CONSERVATION TEAM CONSULTATION APPLICATION RESPONSE

APPLICATION REF:	25/01539/FP & 25/01540/LBC
CASE OFFICER:	TR
APPLICATION SITE:	Holborn Farm, Dane End, Therfield, Royston, Hertfordshire, SG8 9RH
DESCRIPTION OF WORKS:	<i>Extension and conversion of the existing barn into a five bedroom dwelling with associated landscaping, following demolition of non-original stable extension, car port and lean-to structure.</i> <i>Extension and conversion of the existing barn into a five bedroom dwelling with associated landscaping, following demolition of non-original stable extension, car port and lean-to structure. Internal alterations.</i>

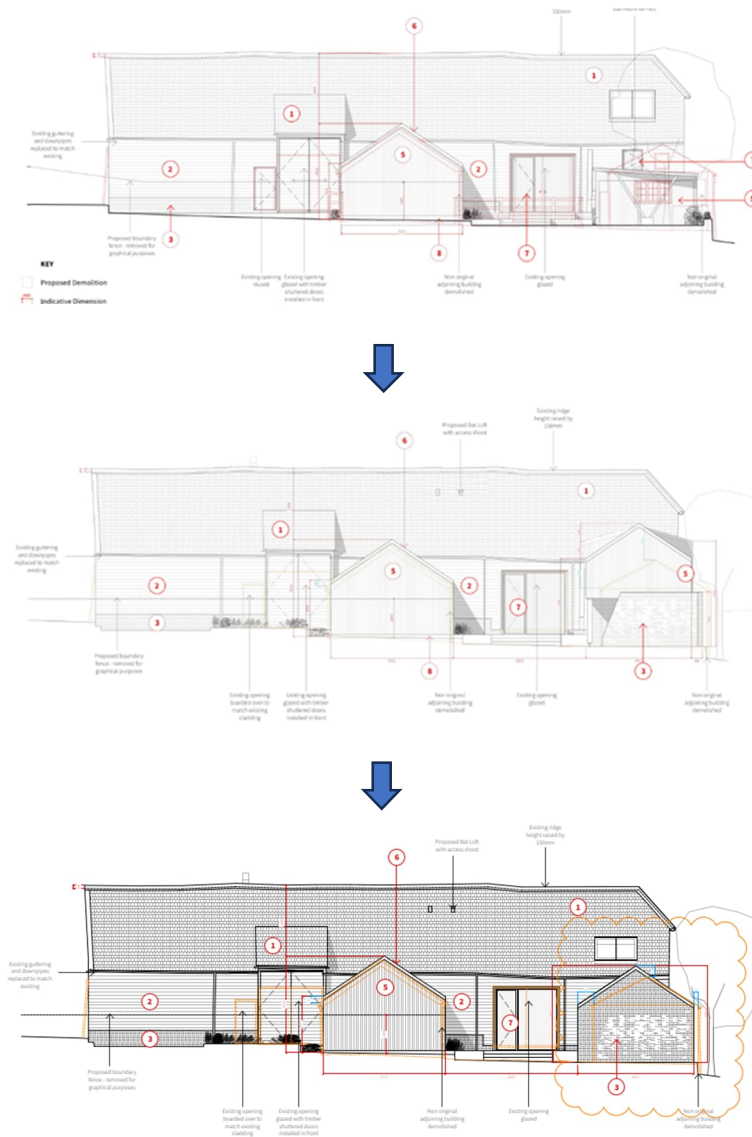
Unless the first floor study is potentially also used as a bedroom, this proposal reverts to a 4-bed scheme.

The changes to the north elevation are welcomed and acceptable.

East Elevation

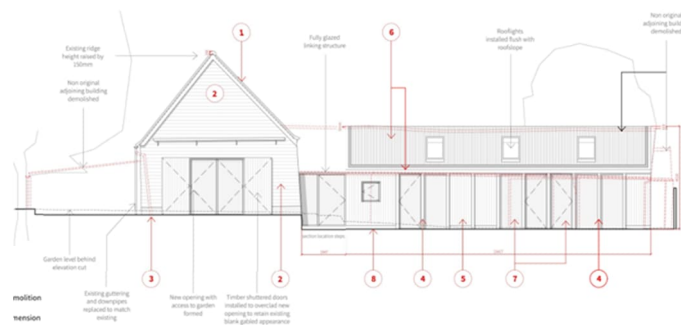
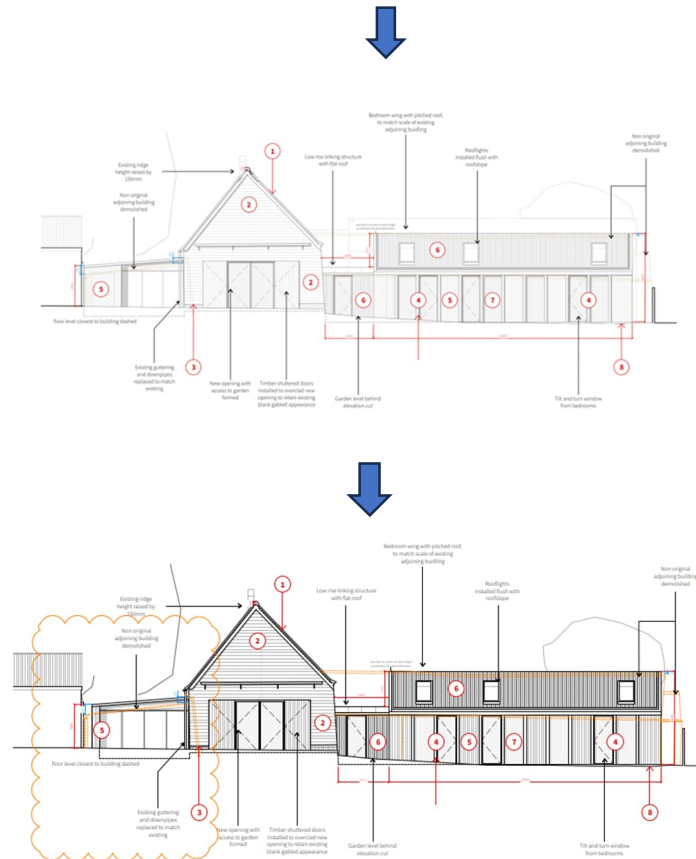
The East Elevation is where the least amount of change is proposed and I found the previous submission unobjectionable. The latest changes to this elevation are considered acceptable.

South Elevation

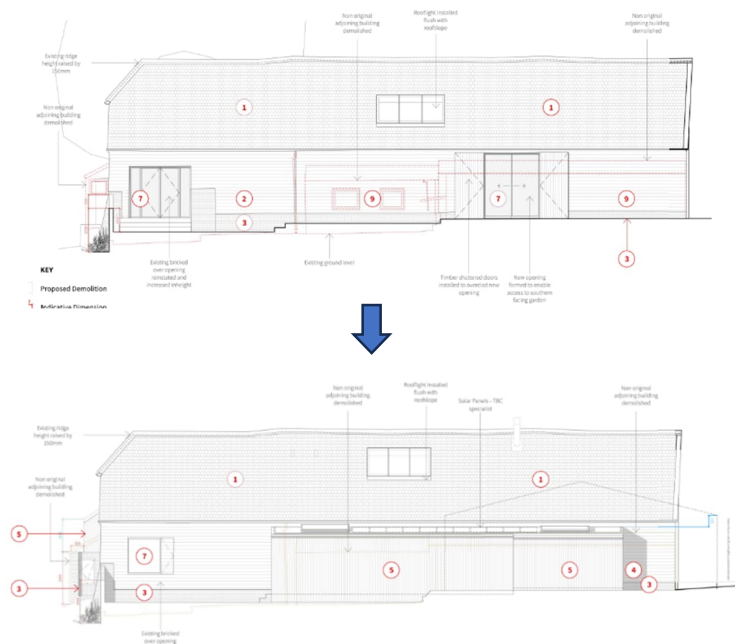
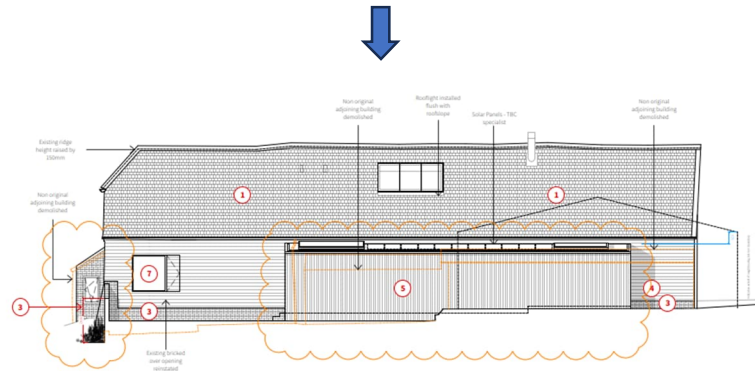
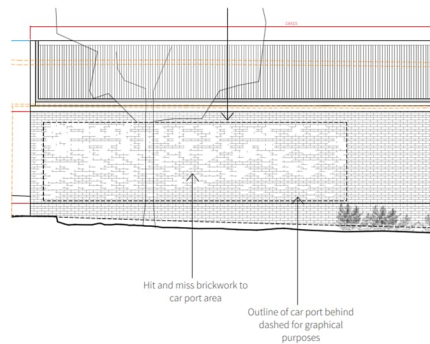
Moving on to the South Elevation, I previously stated that one significant benefit with the extant permission is that this elevation would be better revealed thus aligning with para 219 of the NPPF. Although disappointing to see the single-storey introduced, this still needs to be considered on its own merits. I previously conclude that an addition here in the form suggested, would not occasion harm.

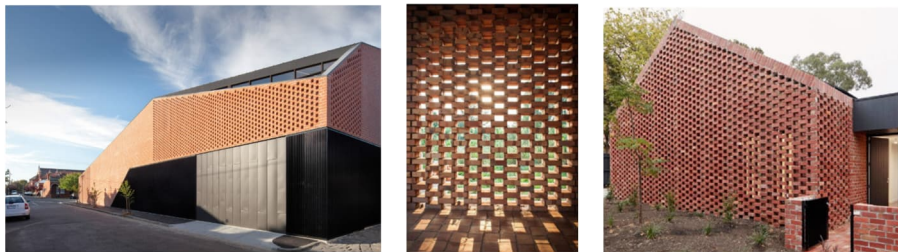
As stated previously, the West Elevation is the elevation that would be appreciated most by those using the adjacent road. This is where I expressed most concern and where the most significant changes have been made and is now considered generally acceptable, however, I have only one further comment to make and that relates to the panel of hit-and-miss brickwork in the image extract below.

There are several variations of this type of brick work and it is unclear from the submission as to whether this would be randomly applied or a precise geometric pattern.

At point 1 above in the architect's email it does say that *"the applicant wanted to note this can be changed to black timber vertical boards to match the other buildings on the site if this is preferred"*. I don't necessarily have issue with hit-and-miss but I question this type of detail if the purpose is broadly that of ventilation. Normally, the traditional method of ventilating brick-built, agrarian buildings may be to adopt a diaper pattern or slit detail (see below).

4. Notwithstanding approved drawing no. 313-Pr Elevation-West Rev P2, further details of the brick type and bond to the triple carport shall be submitted to and approved in writing by the Local Planning Authority prior to the commencement of that part of the development hereby consented. Thereafter, the brickwork shall be completed in accordance with the approved details.

West Elevation

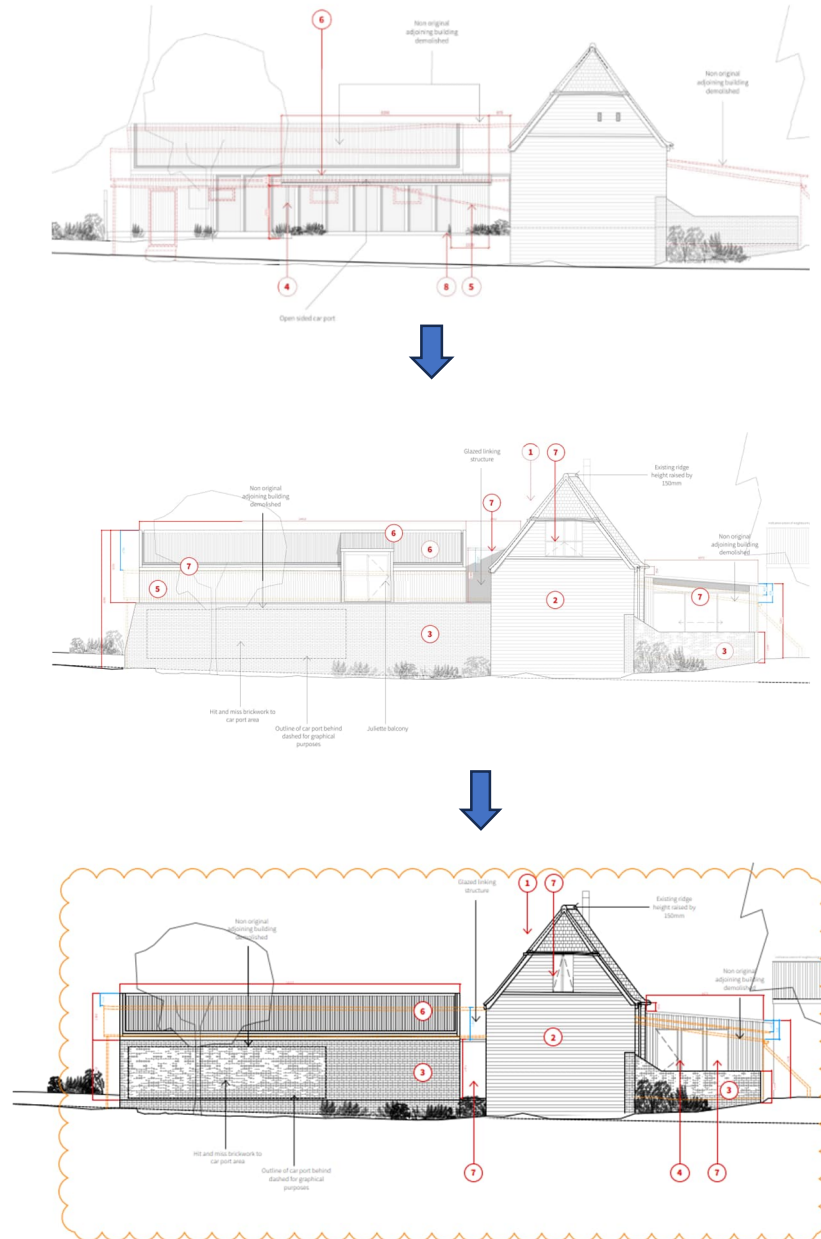
The hit-and-miss approach would potentially have a more contemporary feel and there is not an overly strong case to reject this out-of-hand. Whilst I am not necessarily advocating boarding, I am questioning the type of ventilation brickwork to be deployed and seeking clarification **but this could potentially be handled via condition.** I just feel that this would bring a degree of uniformity to this elevation if either of the above two methods were used.
